*Donnelly Law
Hydrogeological Review - Bacher Construction Pit and Quarry
Township of Algonquin Highlands, Haliburton County, Ontario
BRM-00255020-A0
August 16, 2019*

Figure B. Groundwater Contour Map

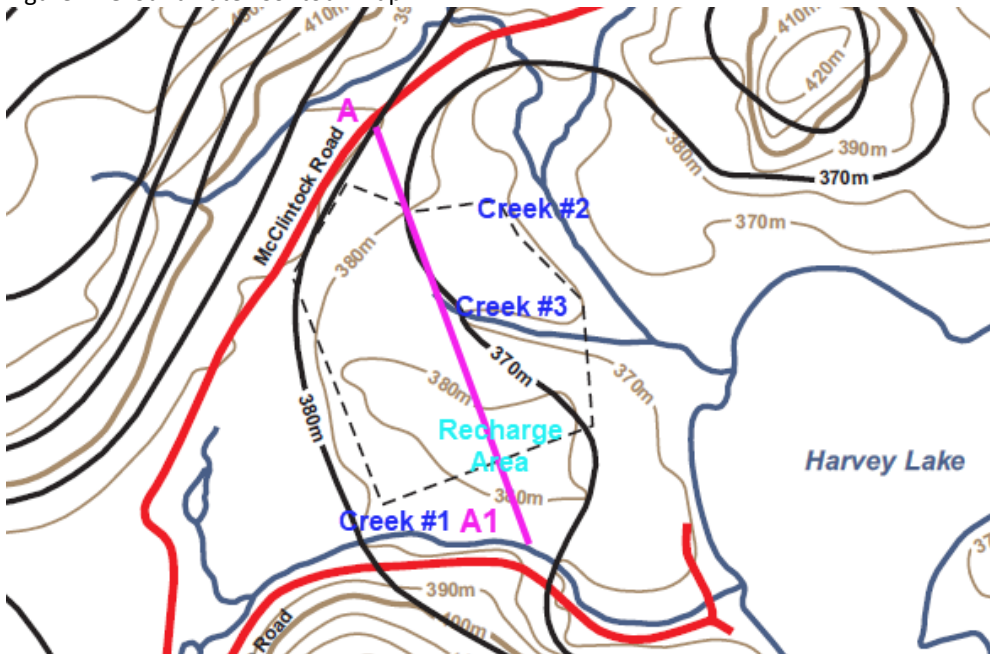
A groundwater contour map for the site was presented on Figure 4 by Waters Environmental Geoscience Ltd. (2016), hereinafter referred to as Waters. A detail of Figure 4 is shown on the appended Figure B.

On Figure 4 of the statement, water levels are sketchily presented with 10 m interval contours, which according to Waters are interpreted to represent the highest groundwater conditions onsite. So far, the site lacks field evidence to characterize it properly, as there are no onsite monitoring wells. To EXP's knowledge, groundwater levels were not measured onsite by Waters and no monitoring program of water levels has been implemented, and no well water well records are reported within 1 km of the study area. Therefore, the claim that Figure 4 of the Waters report is representative of highest groundwater levels cannot be supported. To provide such information, onsite monitoring wells are required, and multi-year seasonal groundwater level monitoring is needed.

For that reason, EXP disagrees with the stated interpretation (representation of highest groundwater conditions), as seasonal groundwater fluctuations and especially high-water levels during spring thaw (freshet) are yet unknown. The document by Waters (2016) rightly claims to be a "Groundwater Summary Statement", which is not a detailed hydrogeological report.

The groundwater contours shown on Figure B suggest discharging conditions to creeks #1 (south) and #3 (center) and recharging conditions between these streams. The assumed horizontal water table in cross-section A-A1 of the final Site Plan by Timber Craft Consultation Inc. (2019), as depicted on Figure C, is inconsistent with the interpretation made by Waters (2016). Generally, under current recharge conditions, the groundwater surface would somewhat mirror the surface topography for low hydraulic conductivity soils/rocks, and it would flatten, if the hydraulic conductivities are high.

Figure C. Assumed Water Table in Cross-Section A-A1

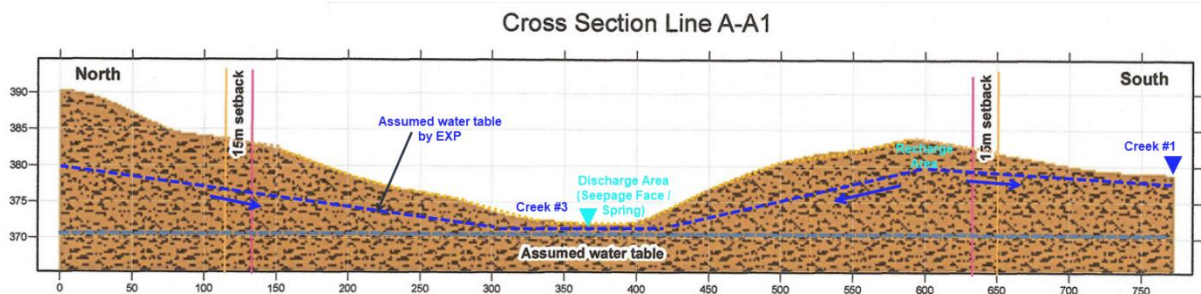
According to cross-section A-A1 presented on page # 2 of the Final Site Plan by Timber Craft Consultation Inc., there are no anticipated potential impacts shown on the horizontal water table. EXP's view on this prediction is that this seems a very unlikely and unrealistic scenario. EXP would expect an alteration of recharge areas and contribution to surface water features, potential effects on water quality (surface and groundwater), disruption of discharge areas and potential impacts on natural features, lowering of water table and changes in flow regime as likely outcomes of the extracting activity. Potential impacts due to the proposed pit/quarry development can be assessed with a detailed hydrogeological investigation.

Figure D Assumed Excavation below the Water Table in Cross-Section A-A1

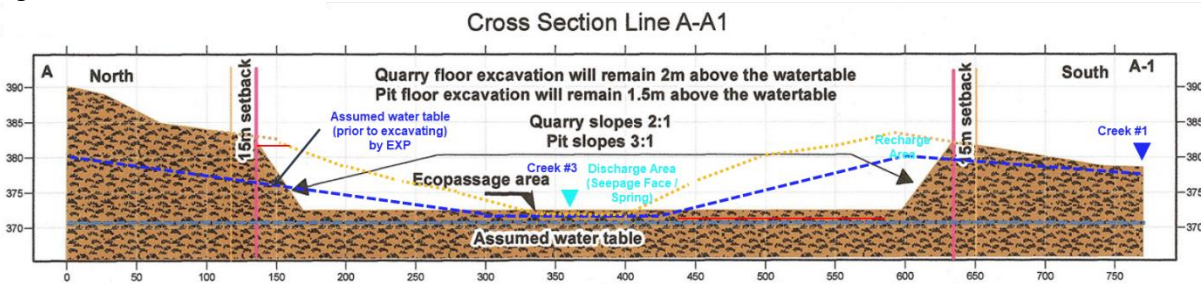
EXP, following the water levels interpretation made by Waters (2016), observes that the water table has relief (as depicted in Figure B) and accordingly, the proposed quarry floor is predicted to be below the water table, as shown on Figure D.

According to policy No. A.R.4.01.04, a minimum spacing of 2.0 m (and 1.5 m) needs to be maintained between the projected quarry (pit) floor and any static water level including seasonal high for bedrock (and overburden), respectively. Waters (2016) states that Bacher Construction Ltd. should avoid extracting bedrock below 382.0 masl in the northwest and 370.0 masl in the east. The elevation limit of 370.0 masl in the east is deemed as too low by EXP, based on surrounding elevation of surface water features, subject to actual field investigations.

EXP has the opinion that the proposed Site Plan by Timber Craft Consultation Inc. (2019) does not conform to the description "as above groundwater extraction of pit or quarry operation", and consequently, cannot be approved for a Category 9 or 11 application under the Aggregate Resources Act.
